Access Compliance Report

Public Rights-of-Way

Intersection ID: 21182	Main Street: BROOKDALE_AV	Cross Street: STARCREST_DR	Location: SW
ADA ID: 5005B2B14FBF	Ramp Type: BlendTrans1	Initial Pass/Fail: Fail	Overall Compliance: No
Severity Score: 10			
Codes/Mitigation Info/Possible Solution		Field Measurements/Component Compliance

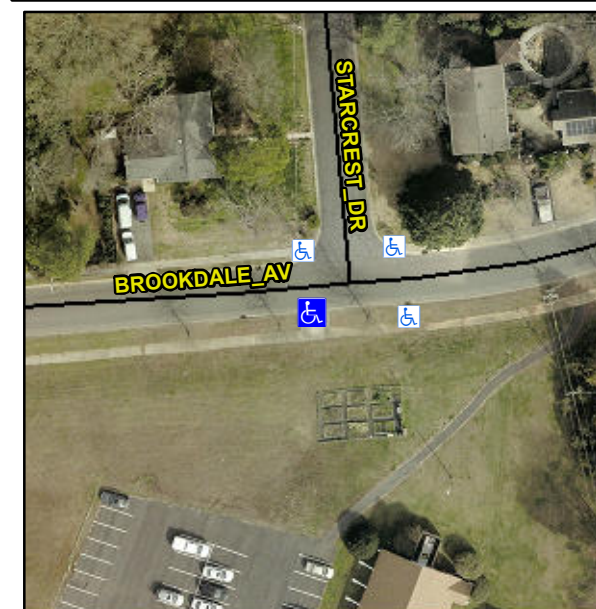
Not Found, R304.5.1, R304.5.3

Compliance	Description	Data	Compliance	Description	Data
N/A	Ramp Length (in)	96.5	Yes	BlendTrans Slope (%)	3.9
No	Ramp Width (in)	47.0	No	BlendTrans XSlope (%)	3.0
N/A	Flare Type LT	N/A	N/A	Flare Type RT	N/A
N/A	Flare Slope LT (%)	N/A	N/A	Flare Slope RT (%)	N/A
N/A	Flare Traversable LT?	N/A	N/A	Flare Traversable RT?	N/A
N/A	Landing Length (in)	N/A	N/A	DWS Provided?	N/A
N/A	Landing Width (in)	N/A	N/A	DWS Contrast?	N/A
N/A	Landing Slope (%)	N/A	N/A	DWS Length (in)	N/A
N/A	Landing X Slope (%)	N/A	N/A	DWS Full Width?	N/A
N/A	Landing Curb? (Y/N)	N/A	N/A	DWS Offset (in)	N/A
N/A	Shared Landing?	N/A			
N/A	Gutter Ponding?	Yes	N/A	Gutter Slope (%)	N/A
N/A	Gutter Lip Ht (in)	N/A	N/A	Gutter X Slope (%)	N/A
N/A	Painted X Walk1?	No	N/A	Painted X Walk2?	N/A
	X Walk 1 Direction	To N		X Walk 2 Direction	N/A
	X Walk 1 Width (in)	N/A		X Walk 2 Width (in)	N/A
	X Walk 1 Slope (%)	2.0		X Walk 2 Slope (%)	N/A
	X Walk 1 X Slope (%)	0.9		X Walk 2 X Slope (%)	N/A

N/A	Ramp inside XWalk1?	N/A	N/A	Ramp inside XWalk2?	N/A
	Road Slope (%)	0.9		Clear Space?	N/A
	Road X Slope (%)	2.0	N/A	Clear Space to XWalk (in)	N/A
N/A	Any Obstructions?	N/A	N/A	Storm Grate/Utility Hazard?	N/A
	Obstruction Type			Storm Grate/Utility Type	
		N/A			N/A
			Yes	Surface Condition? (G/P)	Good
			No	Curb Slope (%)	15.9

Remove & Replace Curb Ramp With Two New Directional Ramps or Equivalent.
